HAWK ESTATES

SW15-00051

COVER SHEET

CITY OF ISSAQUAH - ENGINEERING REVIEW
APPROVED
ALL WORK SUBJECT TO FIELD INSPECTION
5/10/2016

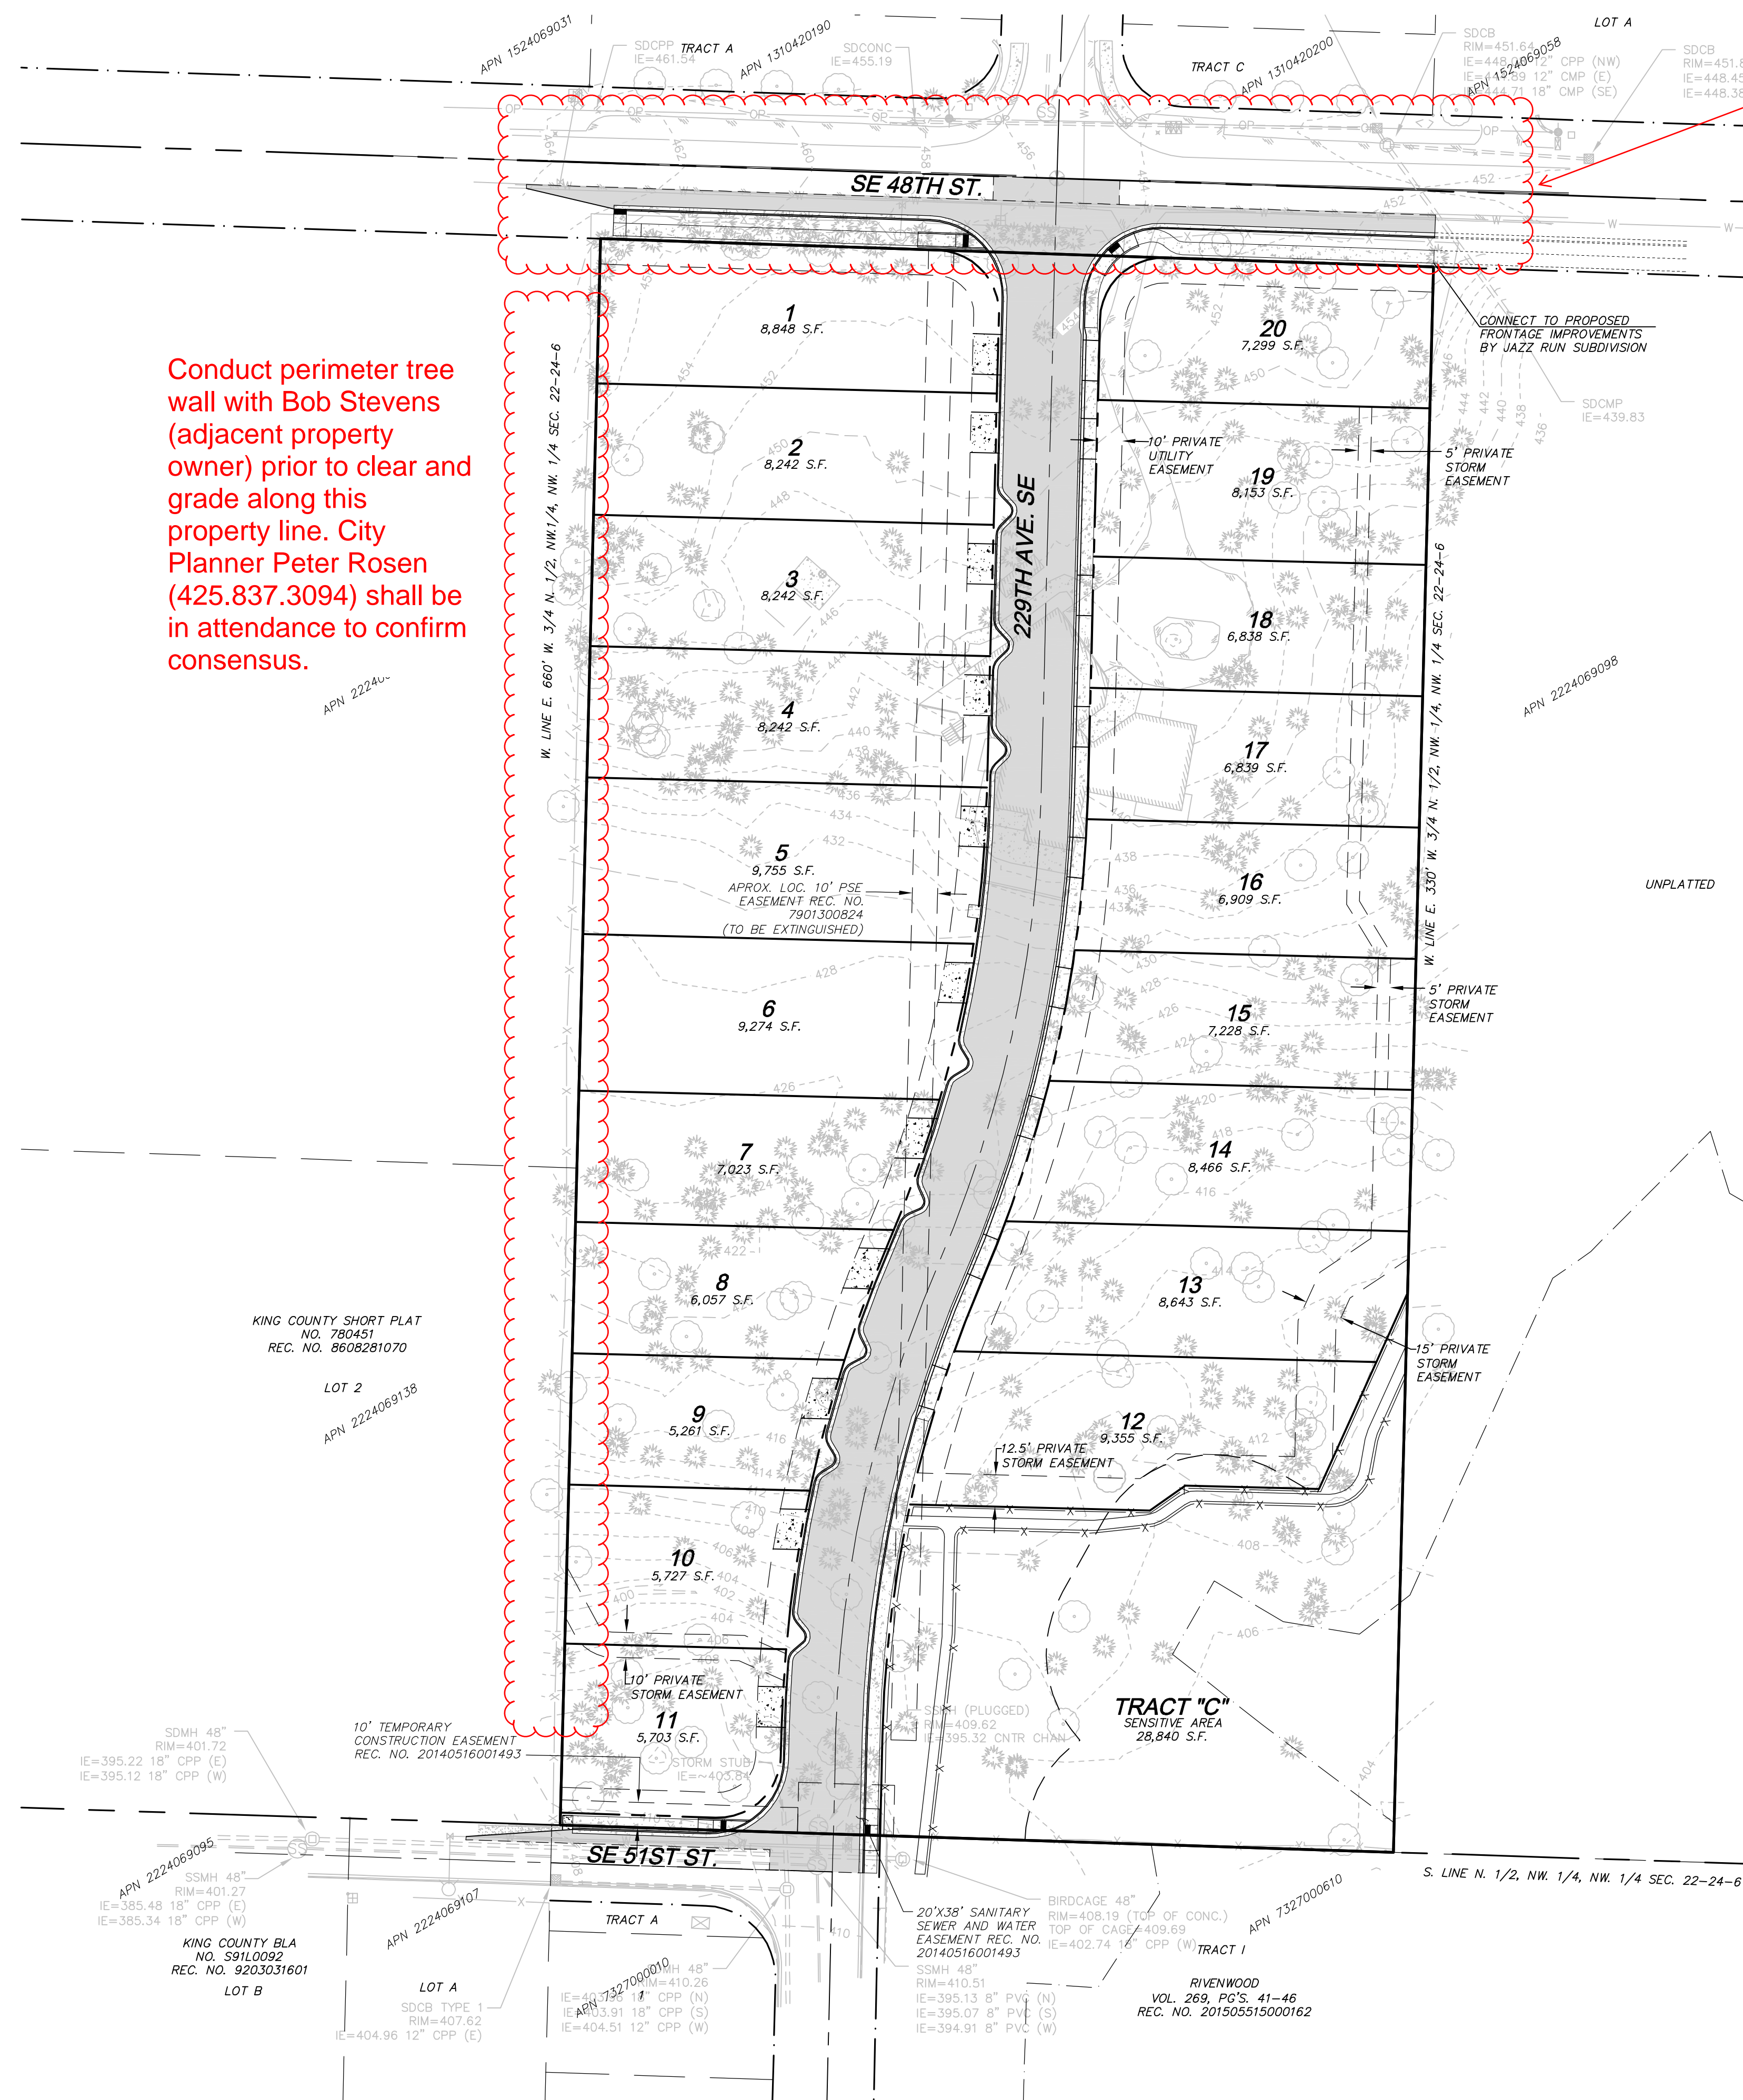
Conduct perimeter tree wall with Bob Stevens (adjacent property owner) prior to clear and grade along this property line. City Planner Peter Rosen (425.837.3094) shall be in attendance to confirm consensus.

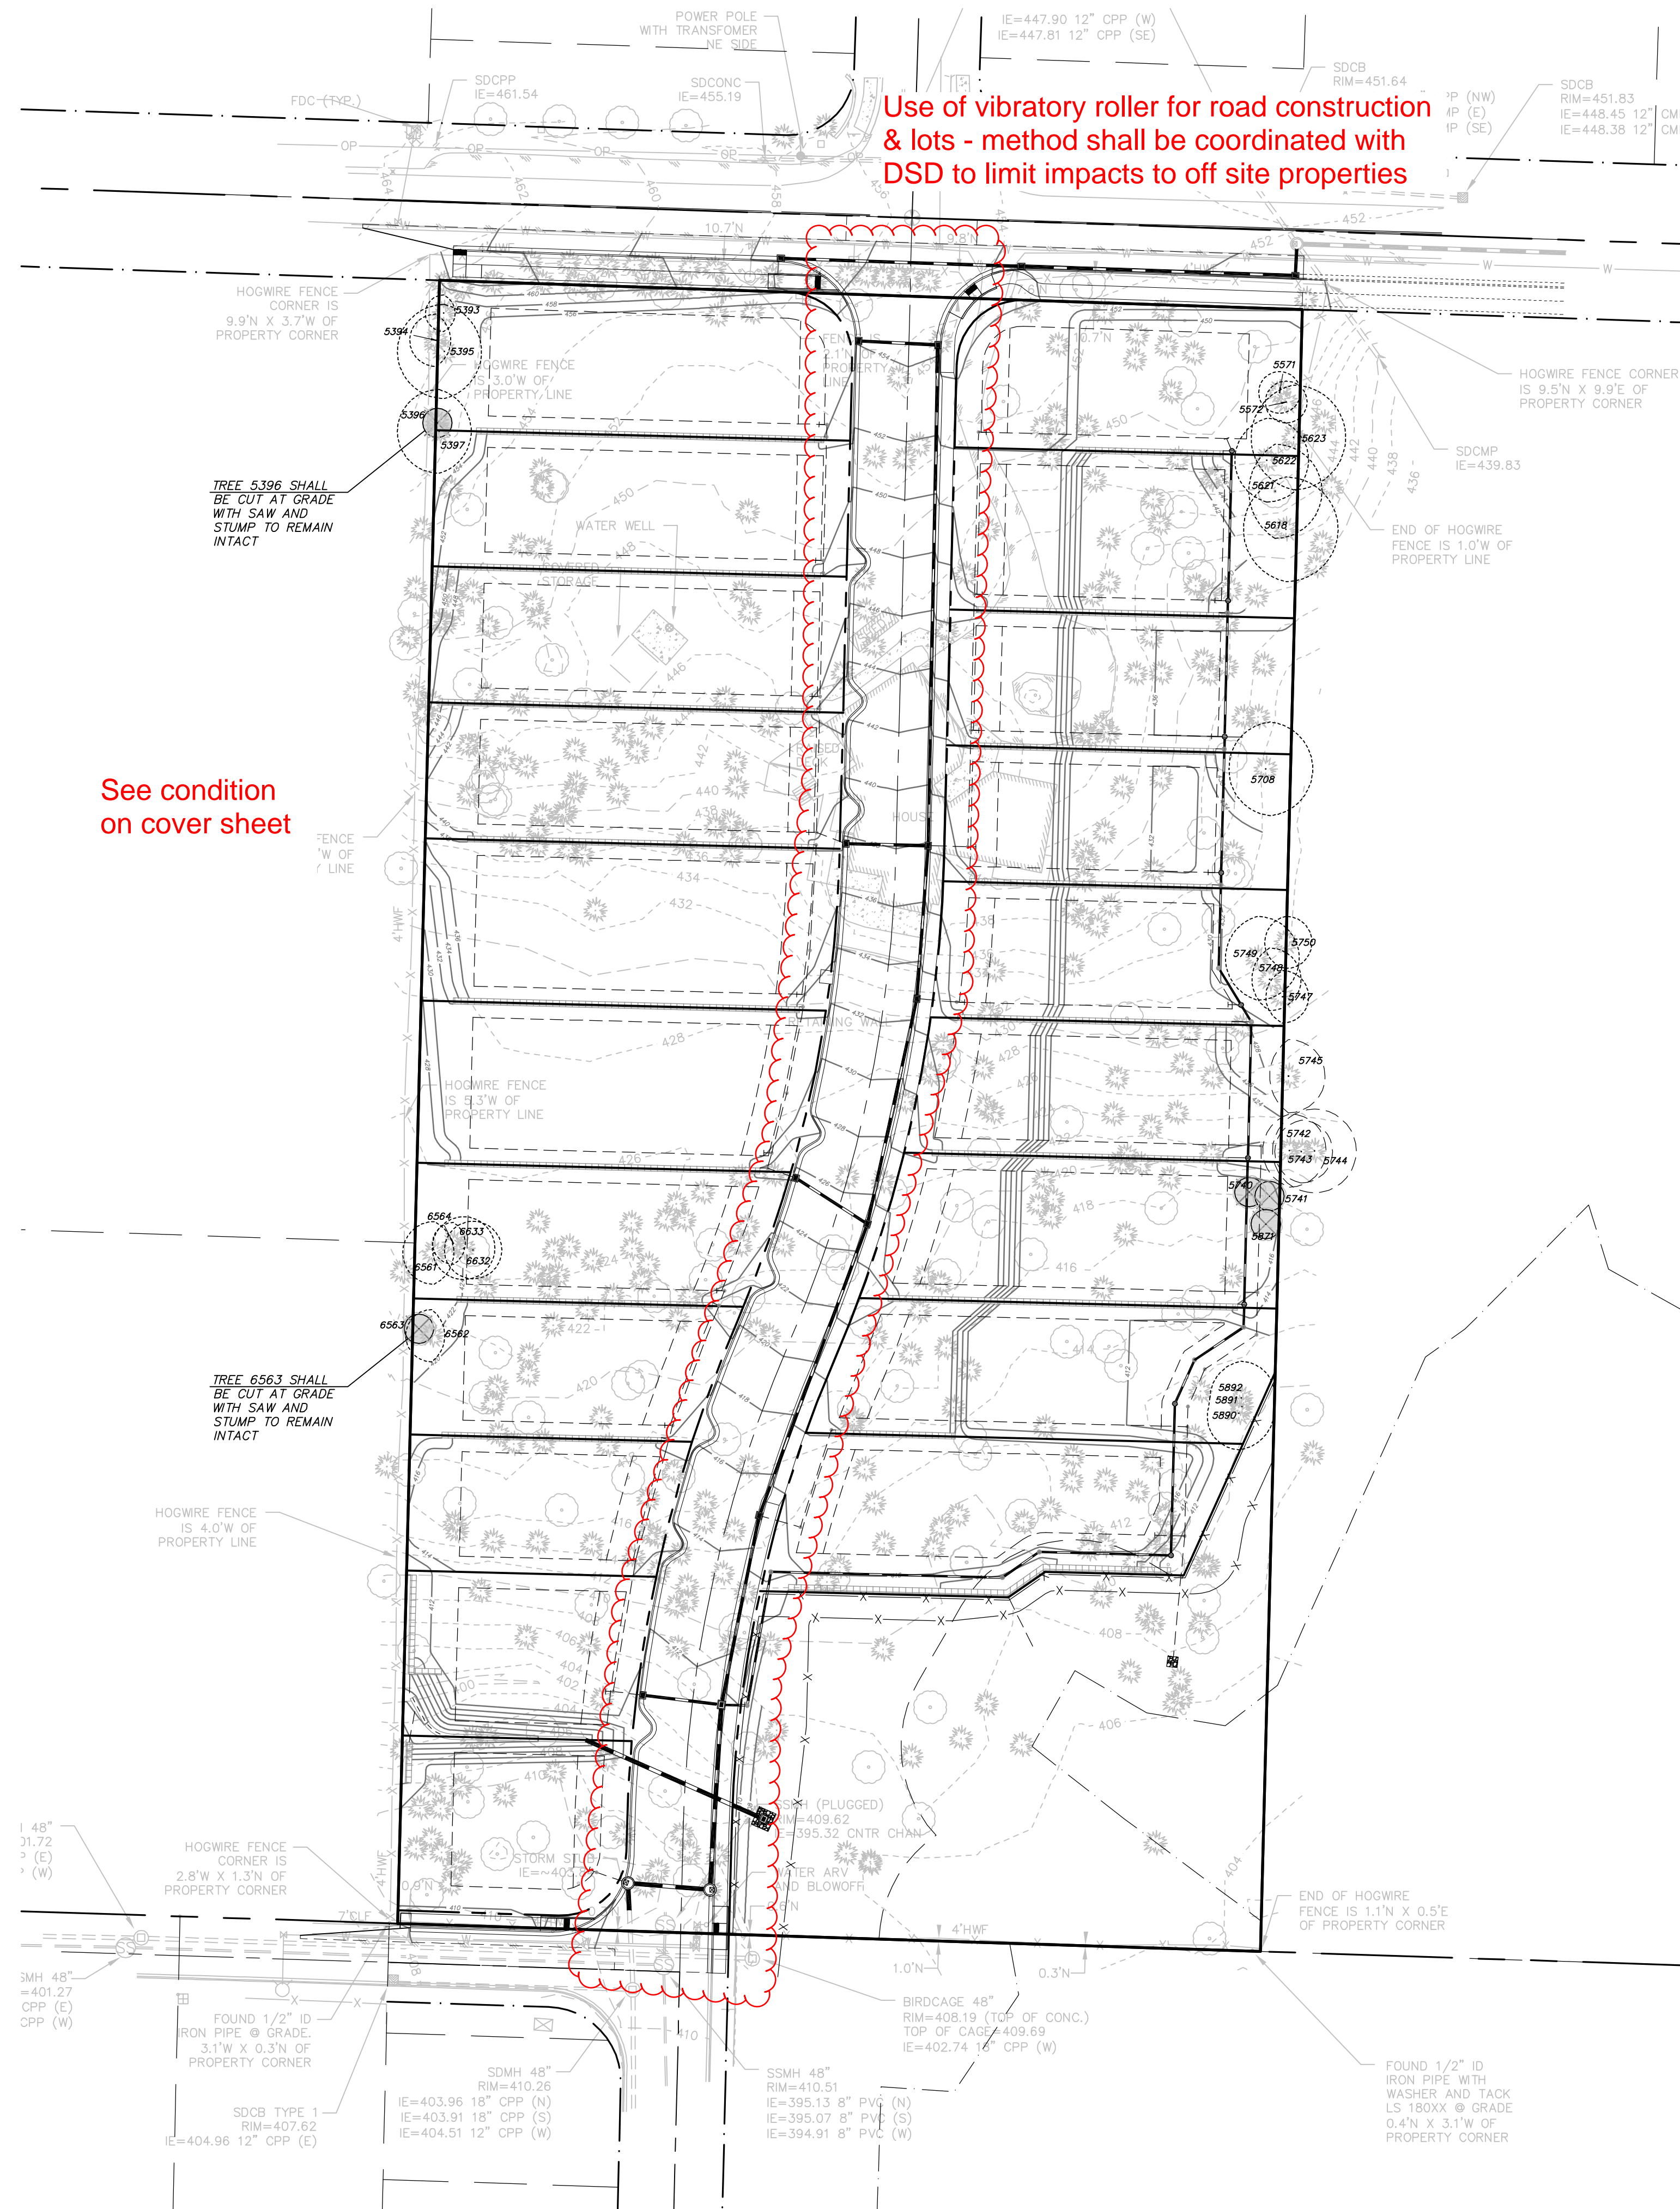
Use of vibratory roller for road construction & lots - method shall be coordinated with DSD to limit impacts to off site properties

See condition on cover sheet

ADA RAMP AND CURB RETURN DETAILS

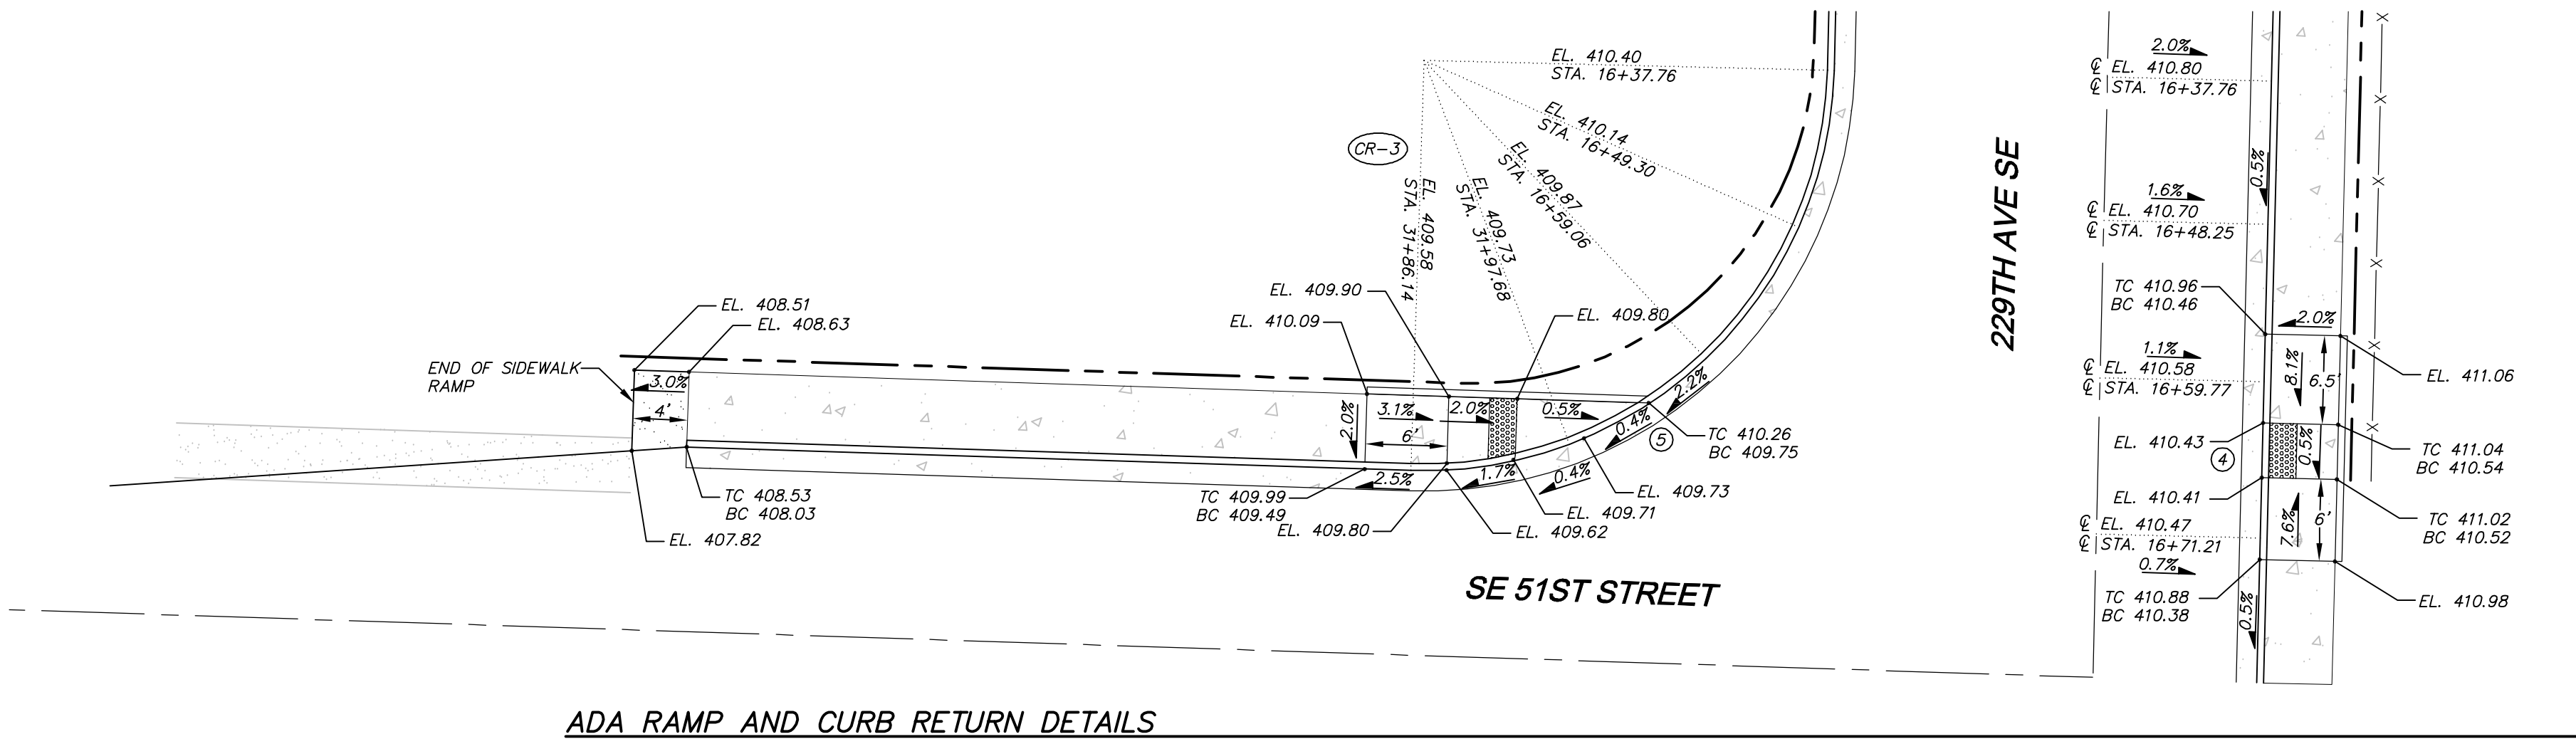
City of Sammamish Approval Required

SE 48TH STREET

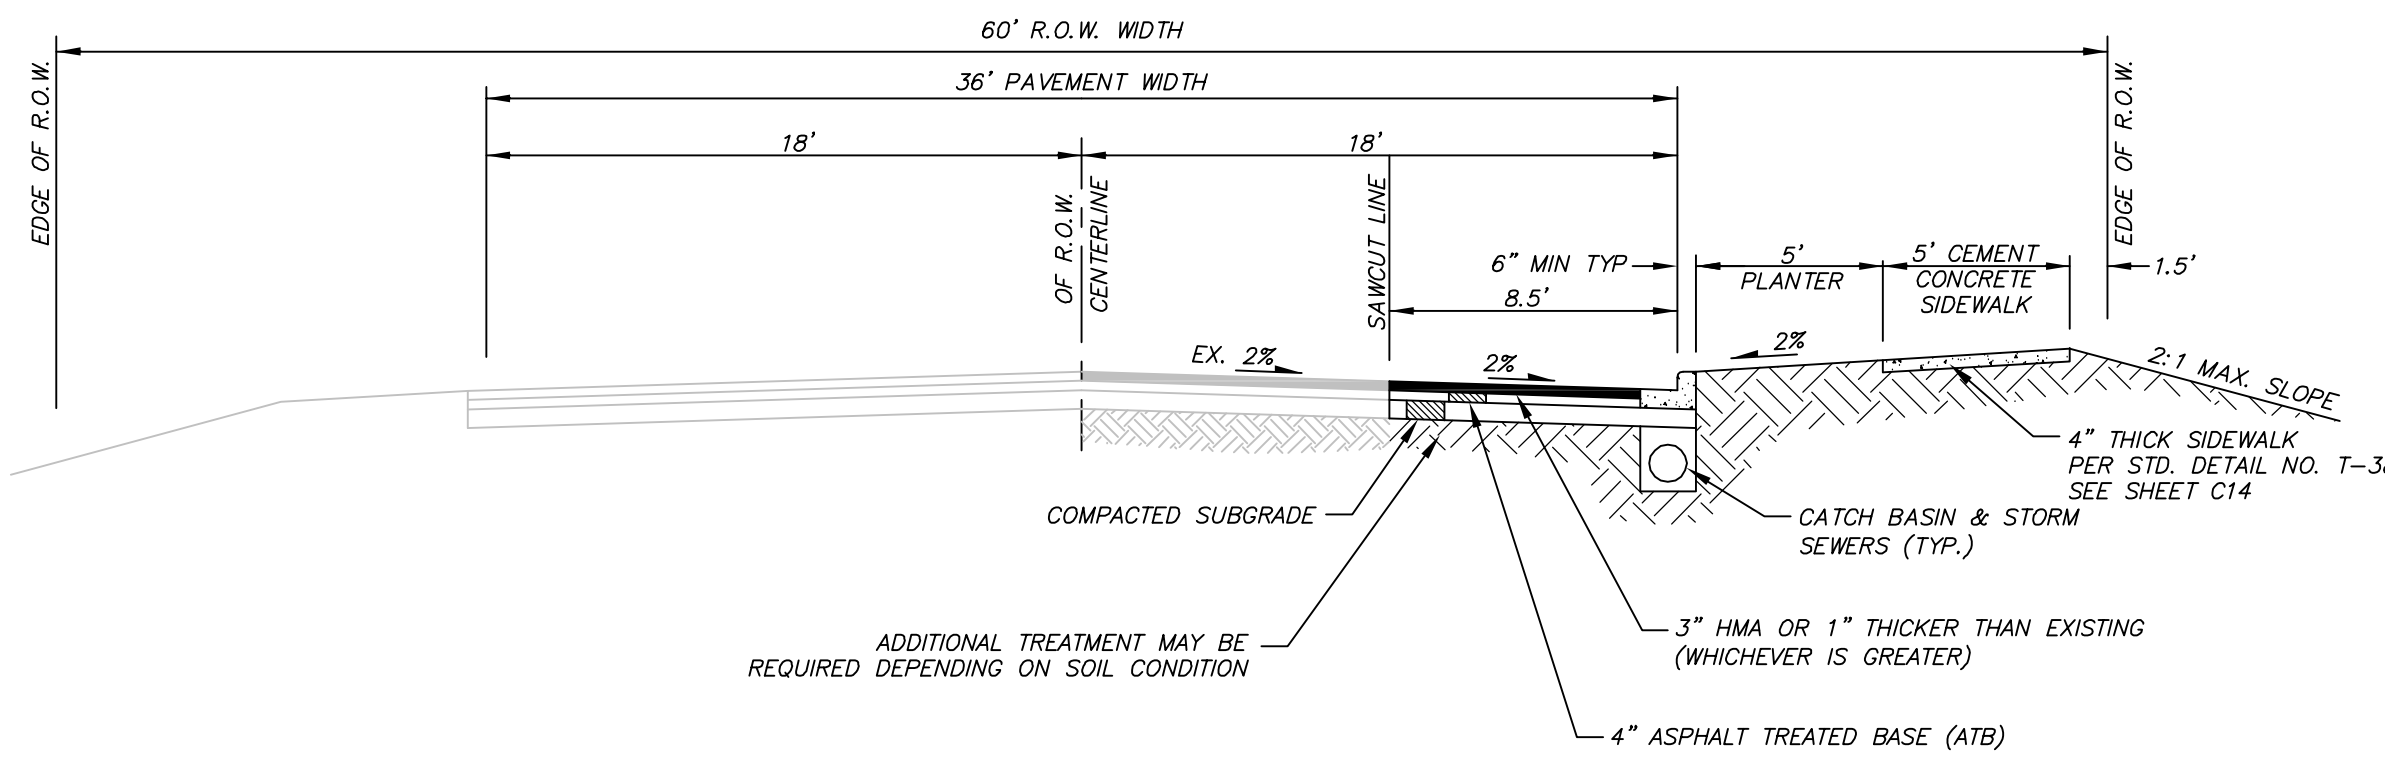
City of Sammamish
approval required
